**City of Portland, Maine – Building or Use Permit Application** 389 Congress Street, 04101, Tel: (207) 874-8703, FAX: 874-8716

Location of Construction: Seven Tampa St		Owner: Ian & Joyce Broadwater		Phone: 828-3688	
Owner Address: Seven Tampa st- Ptld ME 04103		Leasee/Buyer's Name:		Phone:	
Contractor Name: owner		Address:		Phone:	
Past Use: 1-fam w porch		Proposed Use: 1-fam w rebuilt porch		COST OF WORK: \$ 2900	
				PERMIT FEE: \$ 35	
				FIRE DEPT. <input type="checkbox"/> Approved <input type="checkbox"/> Denied	
				INSPECTION: Use Group: Type:	
Proposed Project Description: rebuild porch - bigger (8'x24')				Signature: _____	
				Signature: _____	
Permit Taken By: L Chase		Date Applied For: 5/10/96

Permit No: **960420**

## BUILDING PERMIT REPORT

COMMENTS

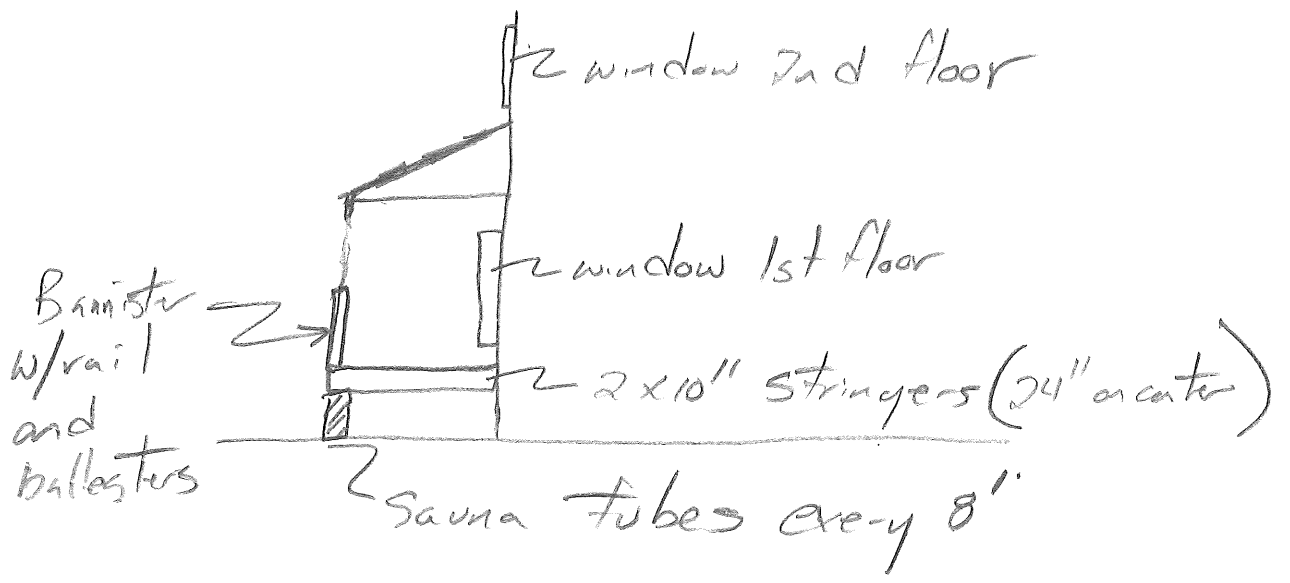
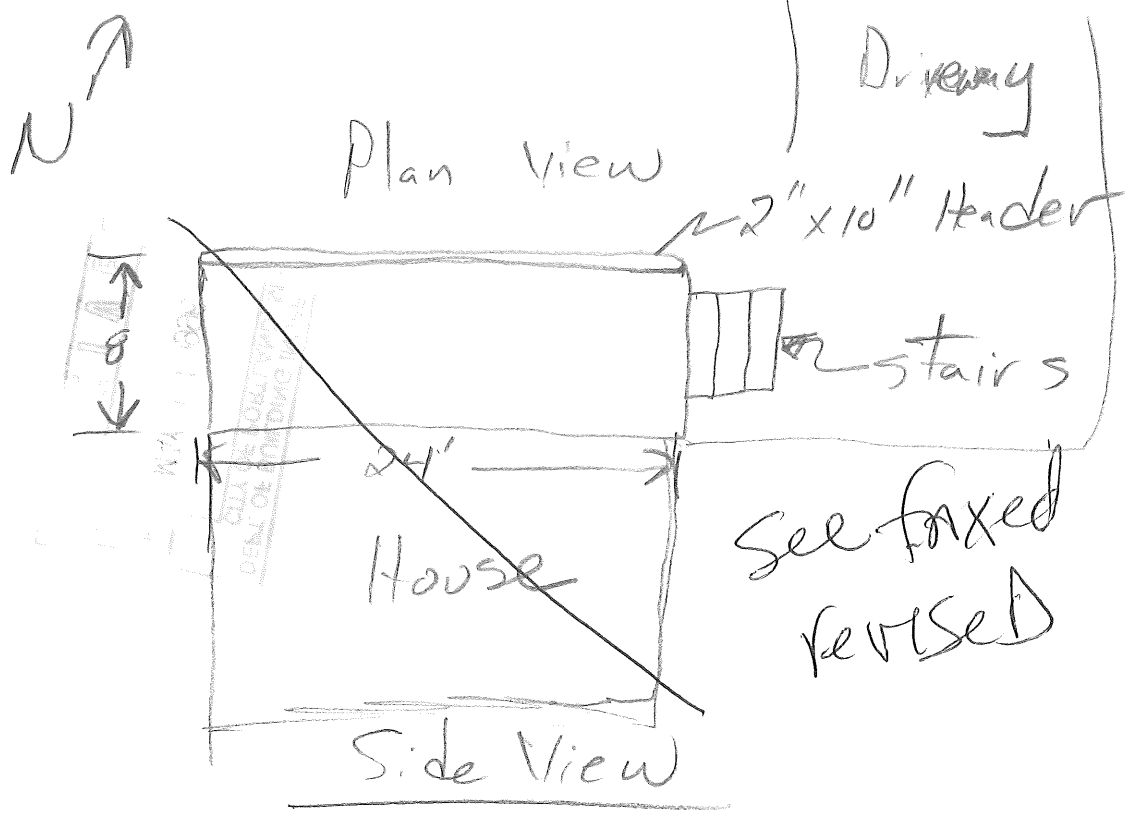
5-29-96 - Sonotube depth OK / 8"  $\phi$  / Setbacks appear OK

6-13-96 - 2x6 rafters 16" OC Guardrail up / Header not visible because of Trim  
does not appear to be 2x10" / will leave open today

most recent  
PLANS

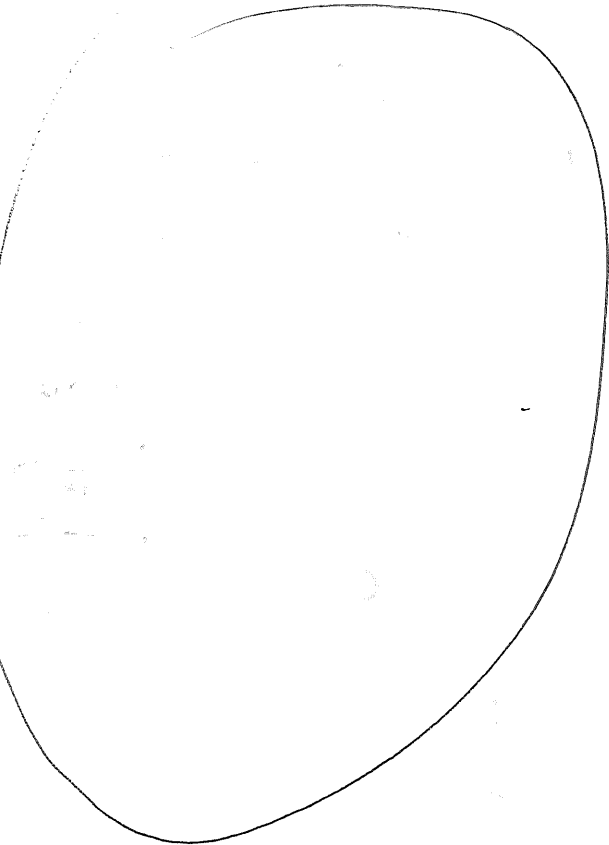
←  
24"  
→

meets

14-425

1) Does not extend  
more than 5'

3) Does not exceed  
50 #
